ADDENDUM NO. 1
TO
PROCUREMENT AND CONTRACTING REQUIREMENTS
FOR
NineStar CR200 Sewer – Division I
FOR
NINESTAR CONNECT
Issue Date: October 25th, 2023

The following, as additions to and modifications in the Bidding Requirements and Contract Documents, will be included in, and become a part of the **NineStar CR200 Sewer – Division I**. This Addendum forms a part of the Contract Documents. Bidders are, therefore, instructed to take the following into account in rendering any Bid for this work. Acknowledge receipt of this Addendum in the space provided on the Bid Form.

CR300 PUMP CONTROL
PANEL LAYOUT DETAILS

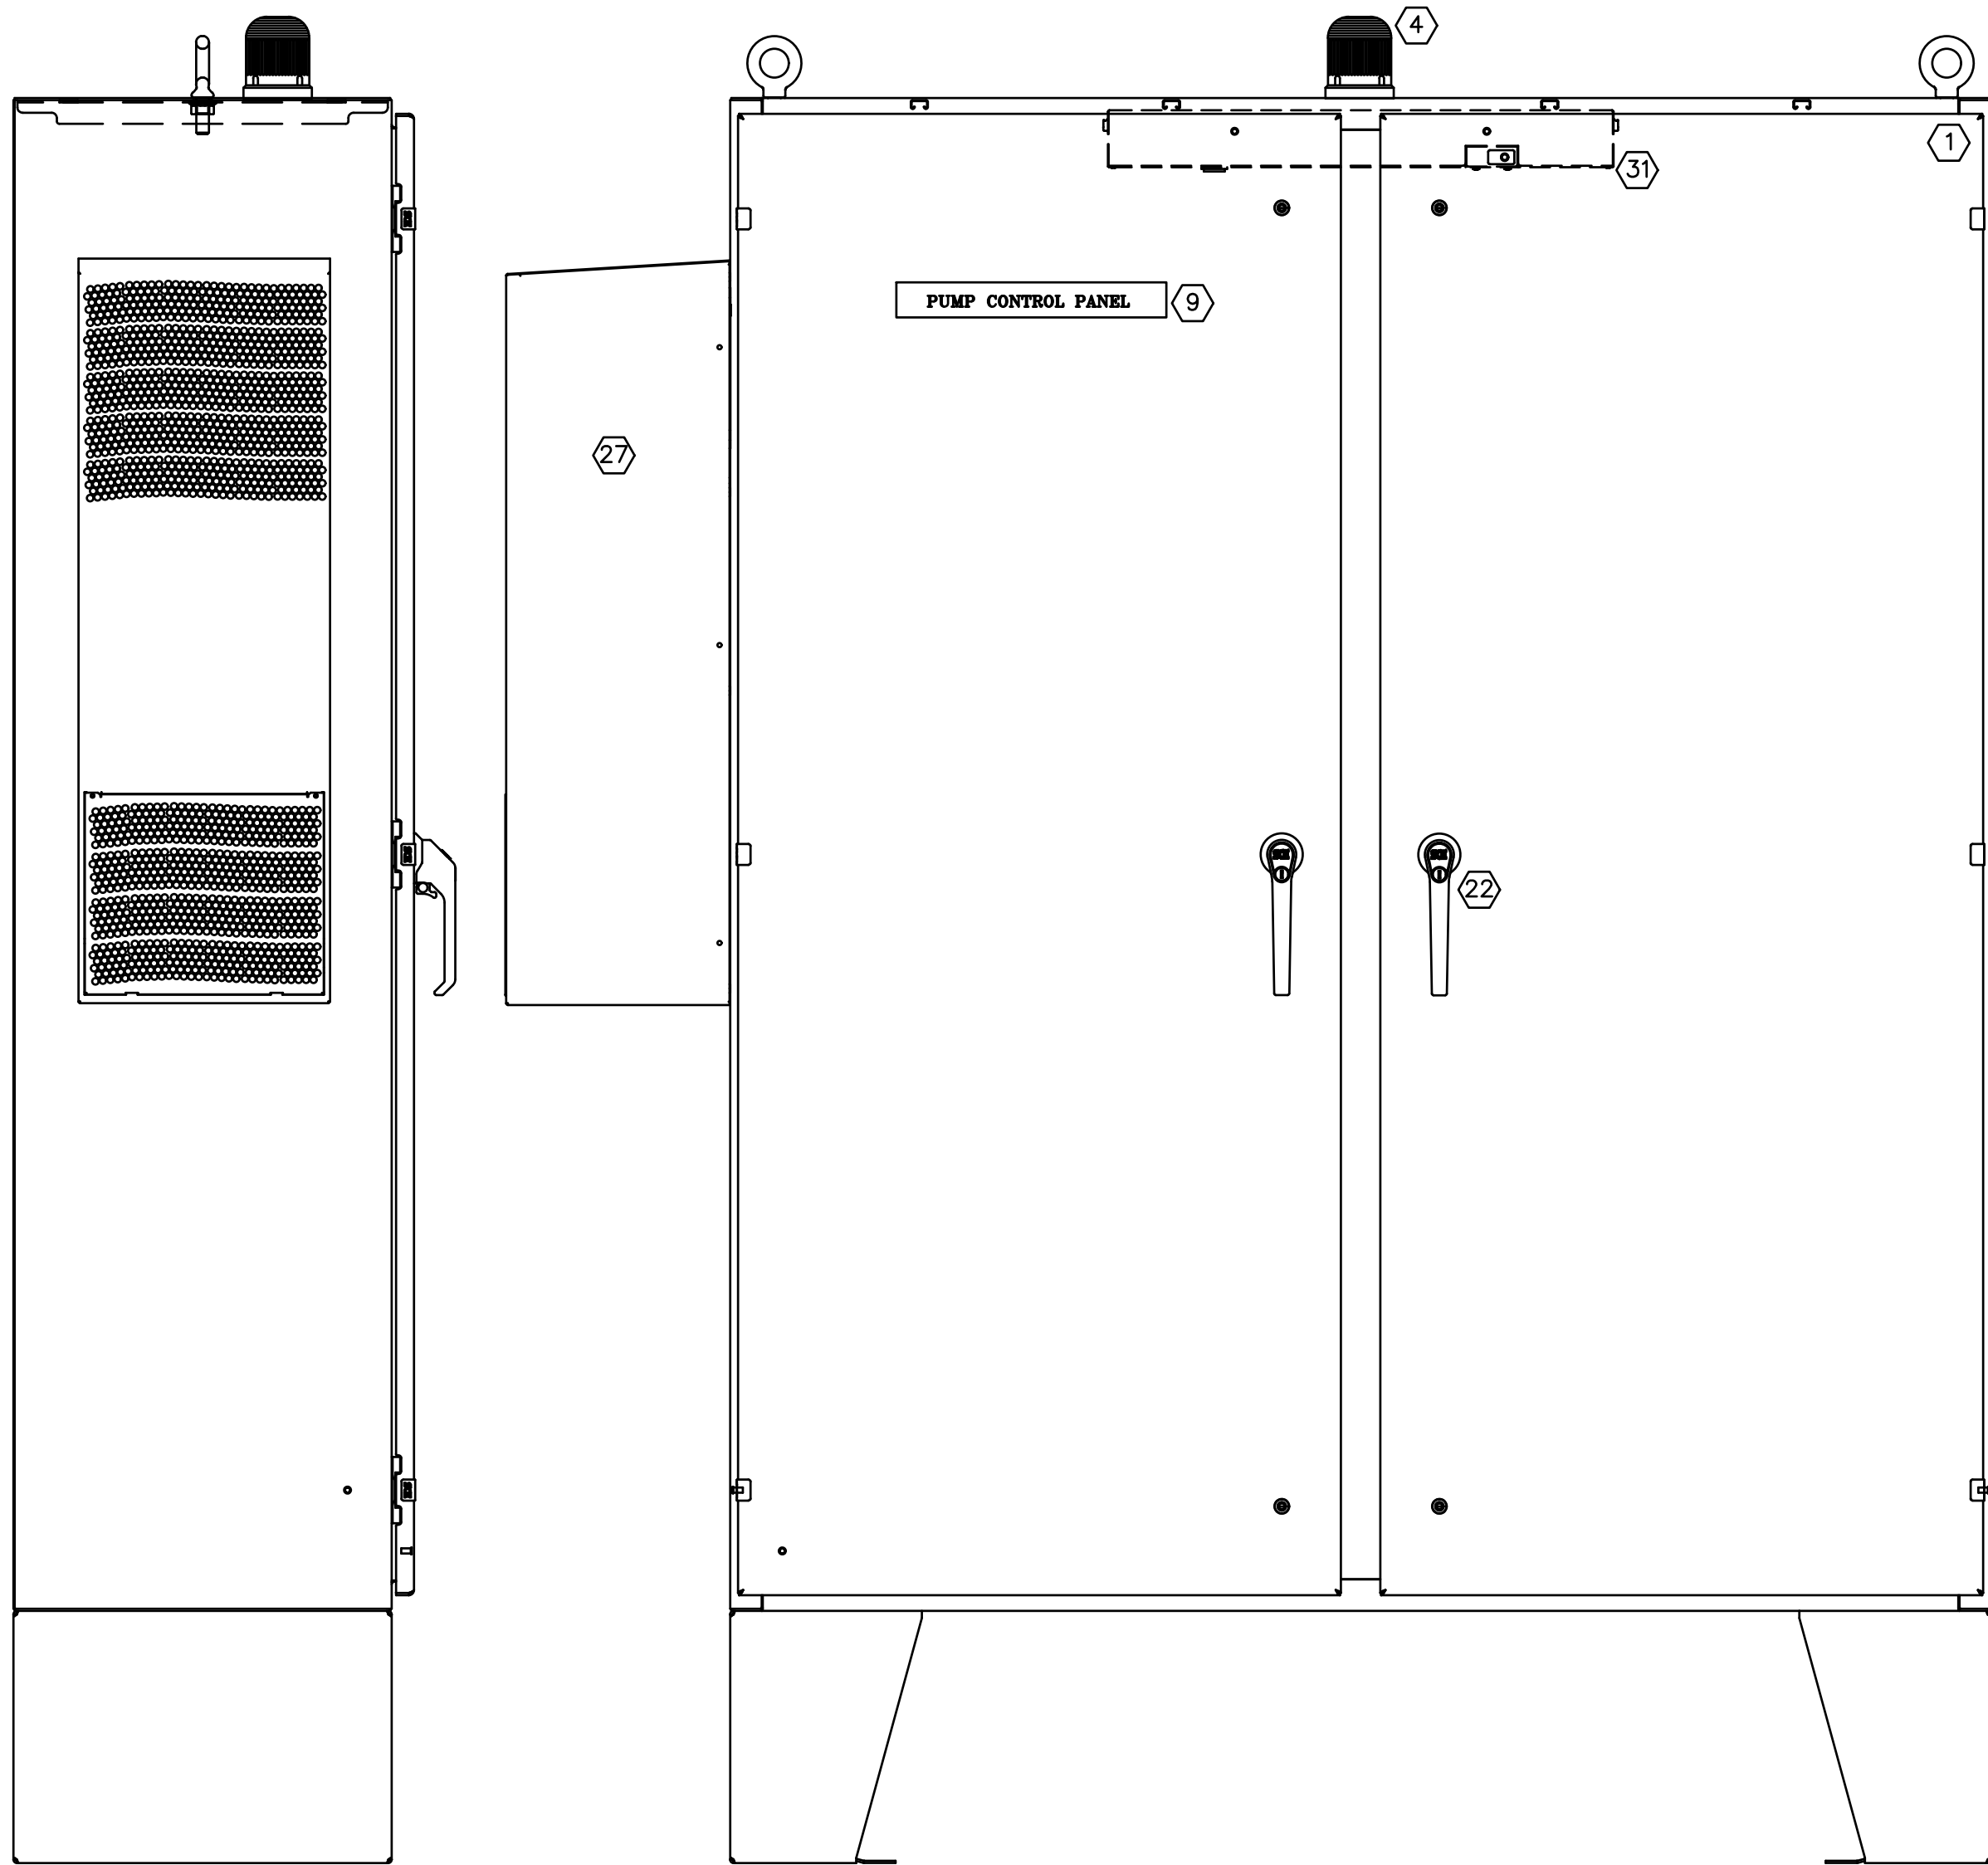
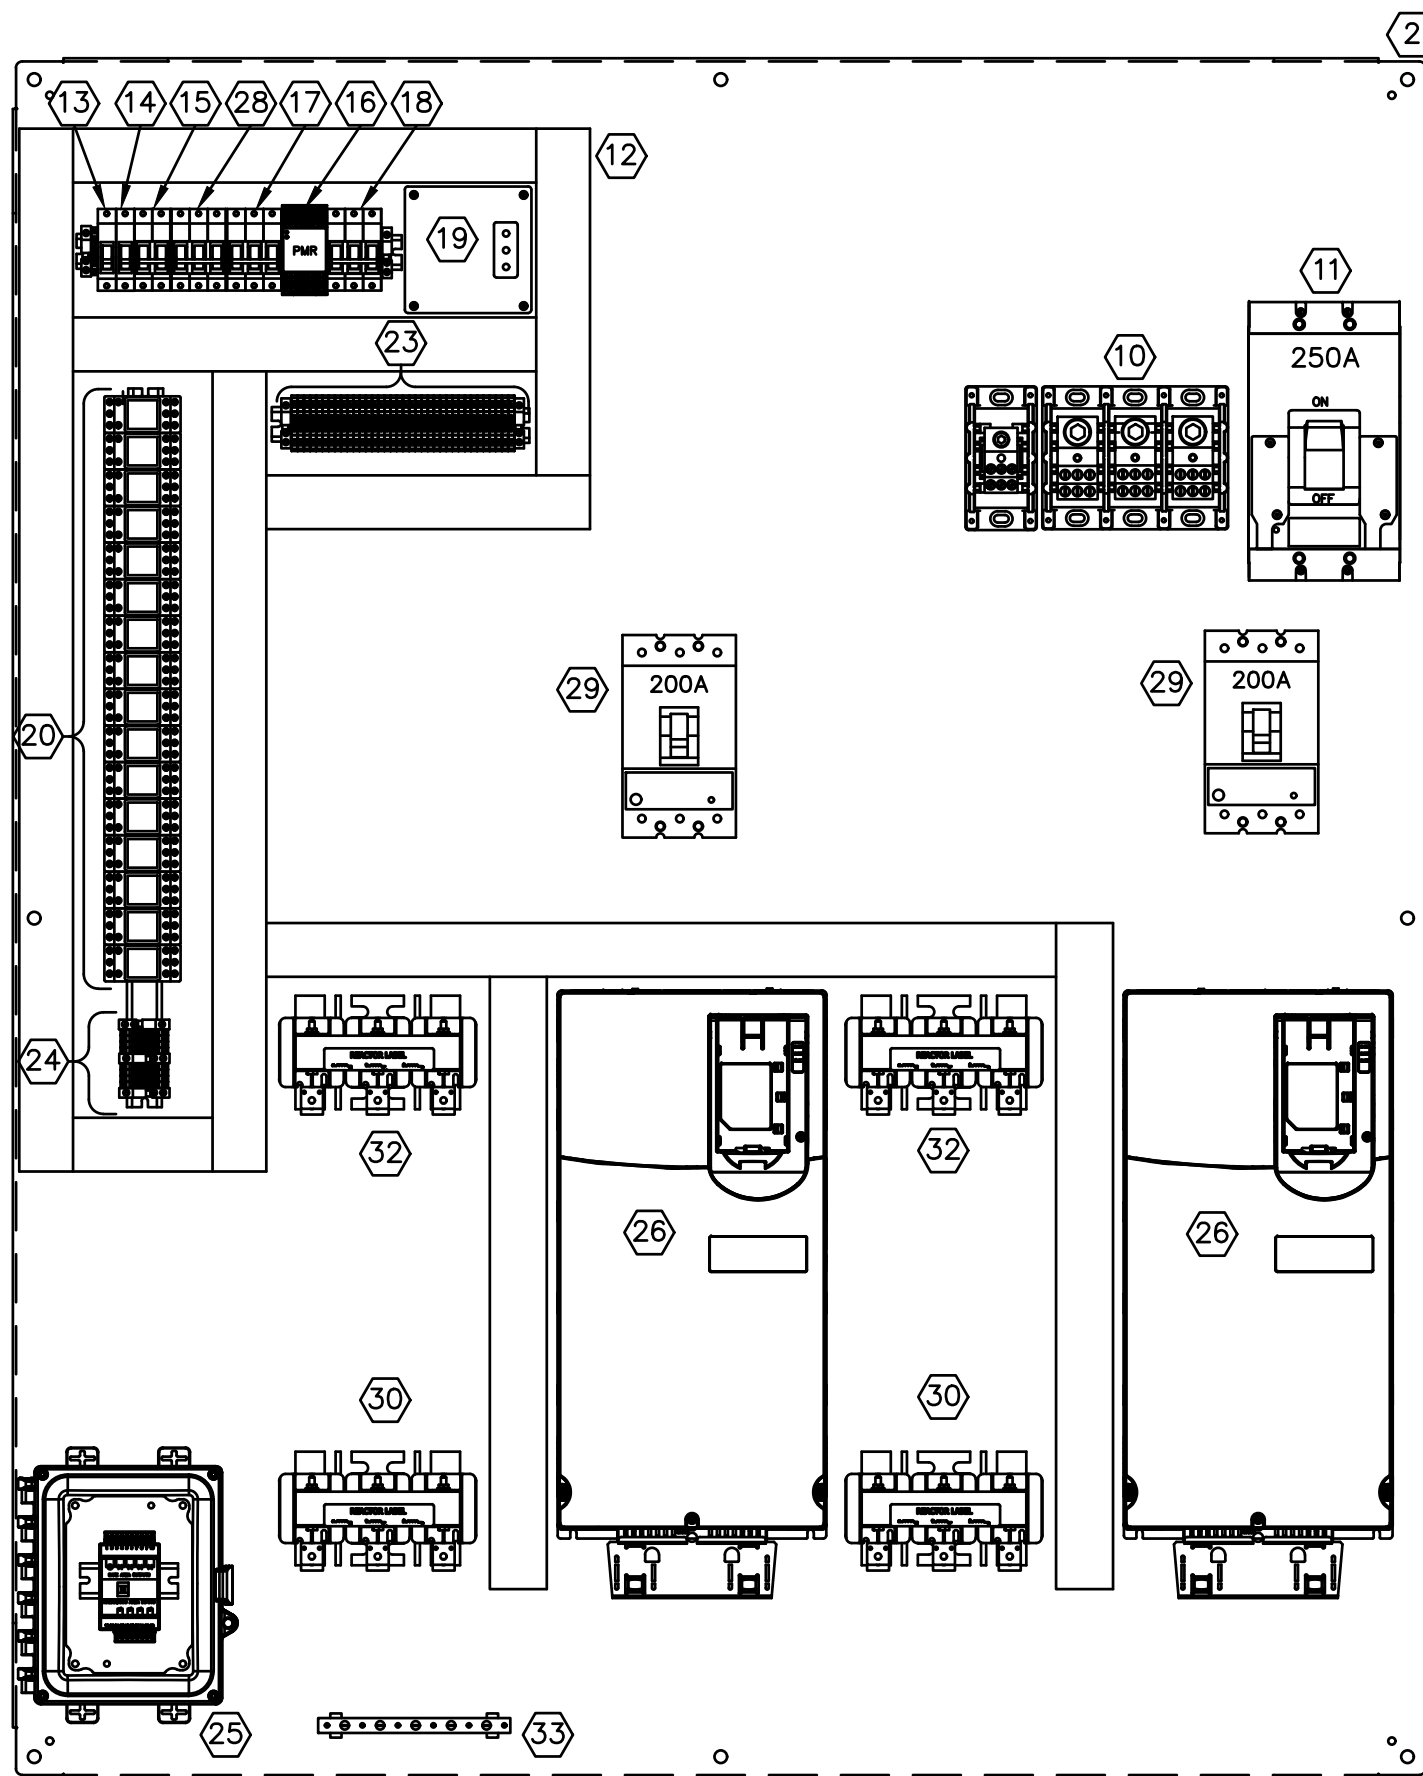
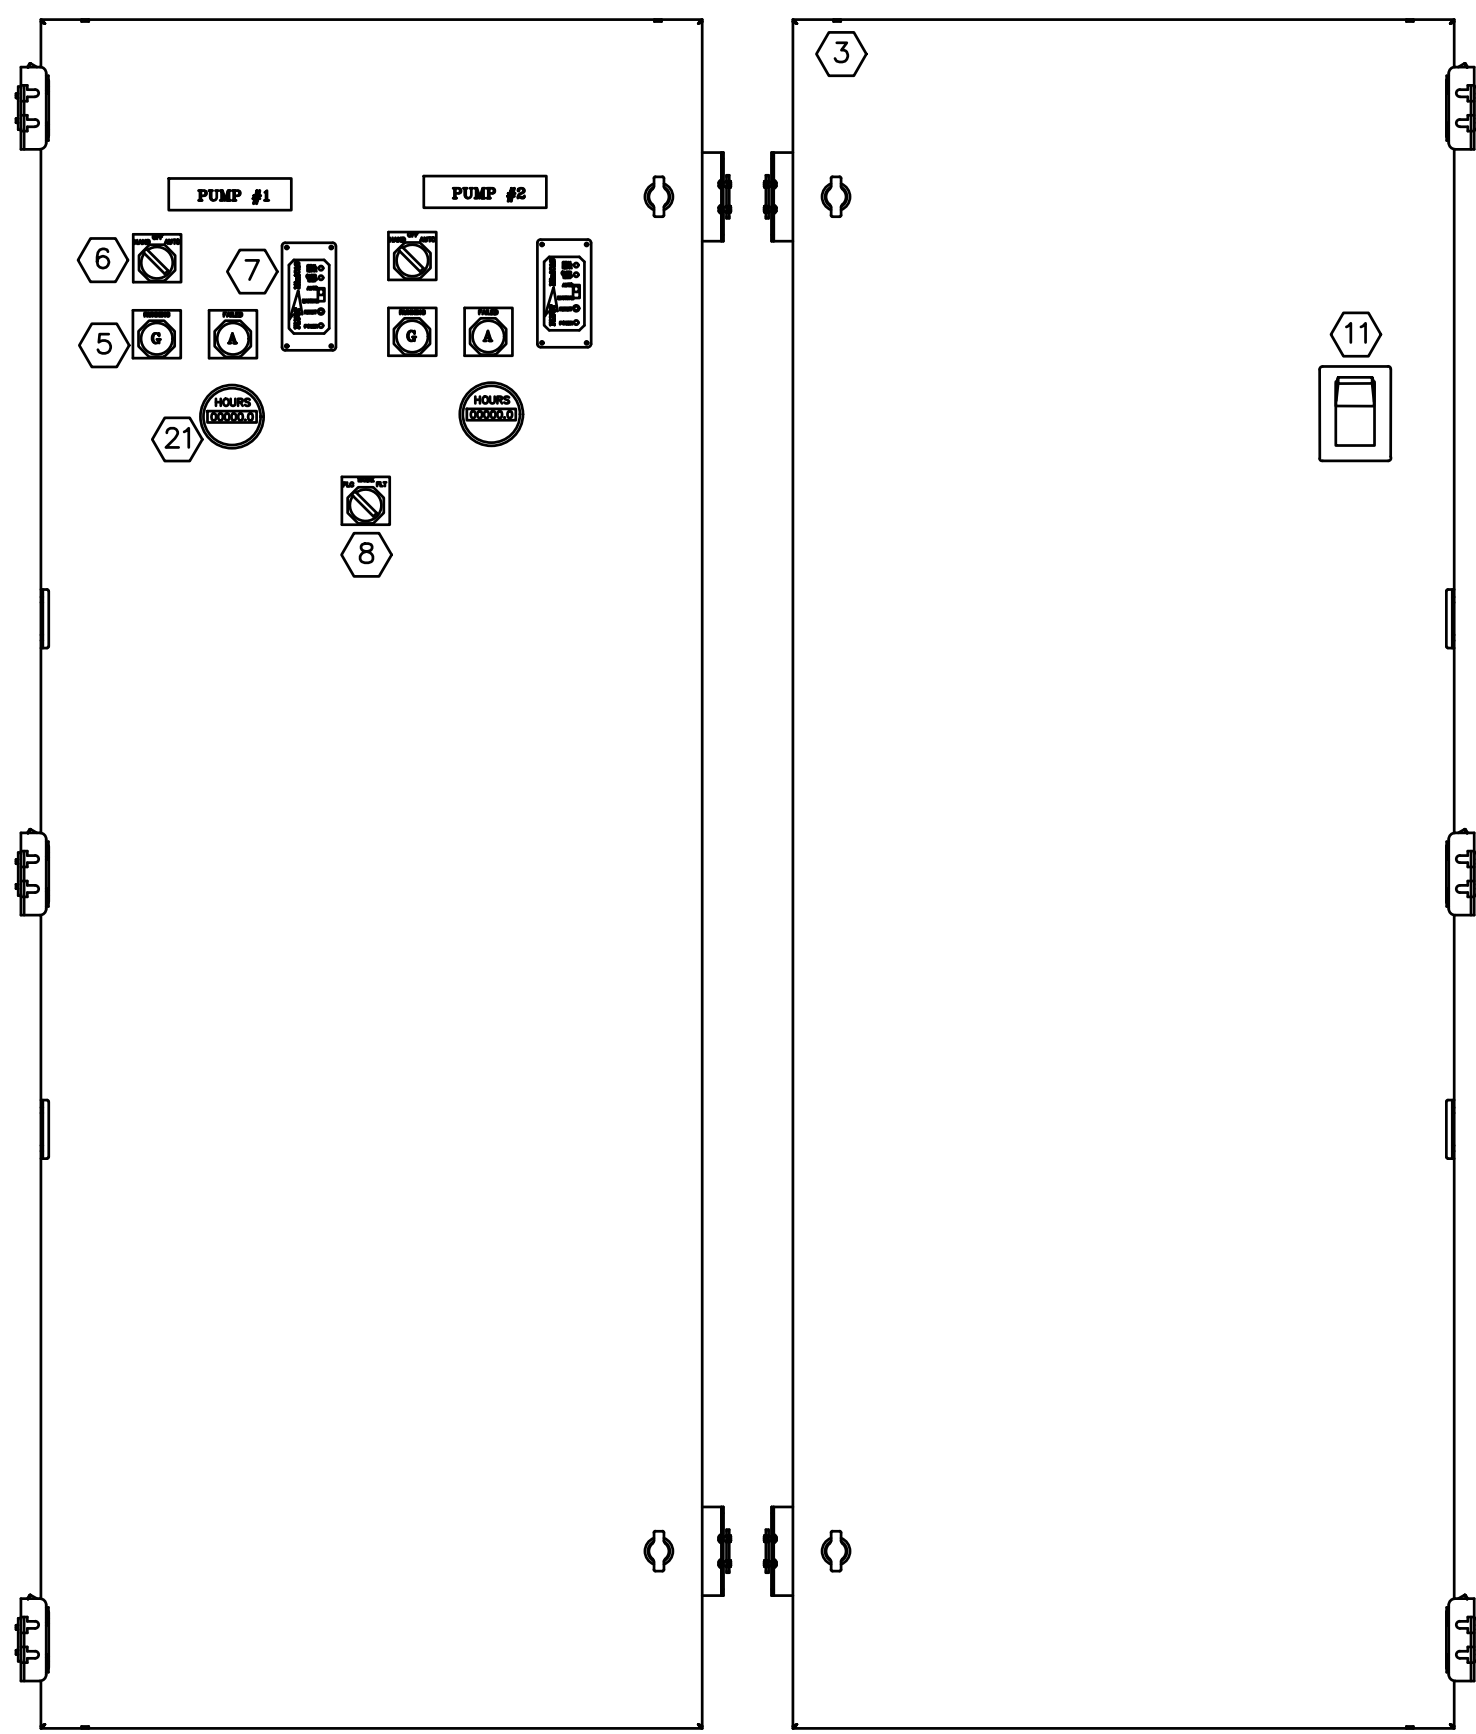
- p. Sheet E303 – CR300 Pump Control Panel Layout Details (Added note about AC/Unit Heater)
- q. Sheet E304 – CR300 Pump Control Panel Wiring Details (Adjusted pump size.)
